December 21, 2018

Version 1

## Hood Will Not Open

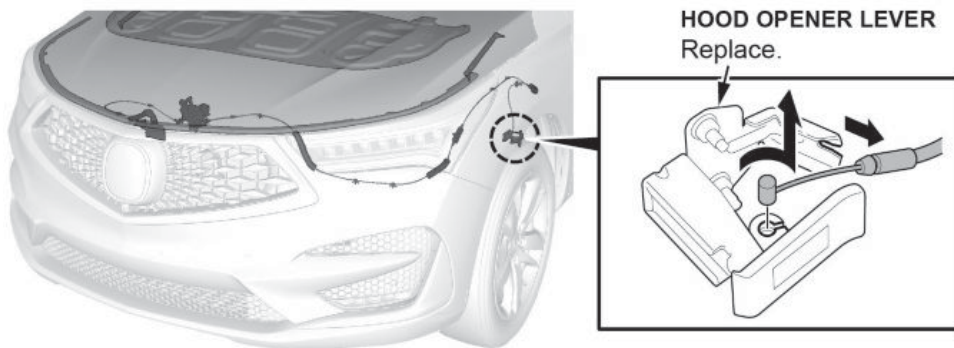
- If the junction box is open, go to step 5.
  - If the junction box is not open, open it, and check if the cables are in the correct position.
    - If the cables are not in the correct positions, go to step 5.
    - If the cables are in the correct positions, this bulletin does not apply. Proceed with normal troubleshooting.
5. Remove the rear hood opener cable from the junction box.

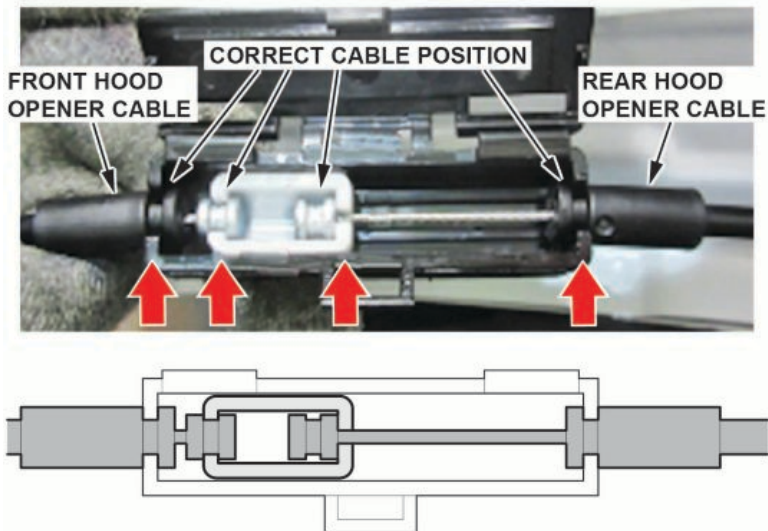
- Make sure the cables are installed correctly in the junction box.
- Only replace the rear hood opener cable.

7. Install a new hood opener lever.
8. Install a new rear hood opener cable.

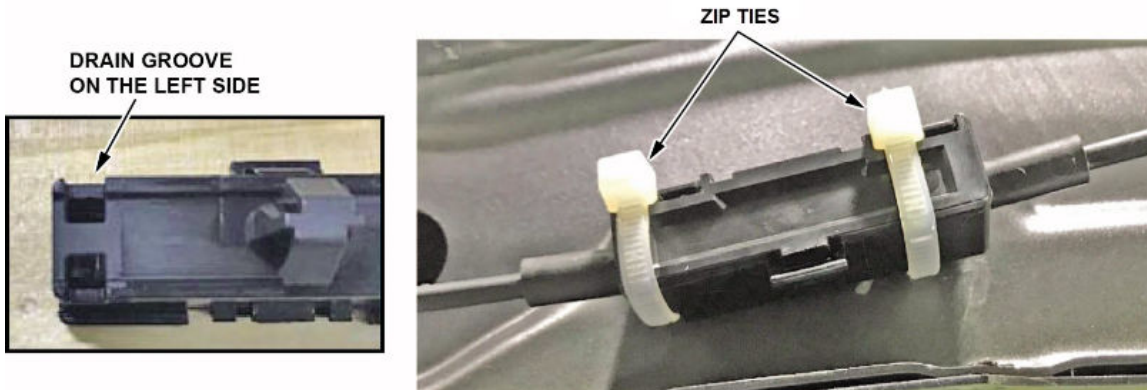
- The zip ties must be 2-4 mm wide to fit properly in the drain groove.
- Make sure the zip ties are installed tightly, and the left zip tie is installed in the drain groove on the junction box.

9. Close the junction box and install two zip ties.
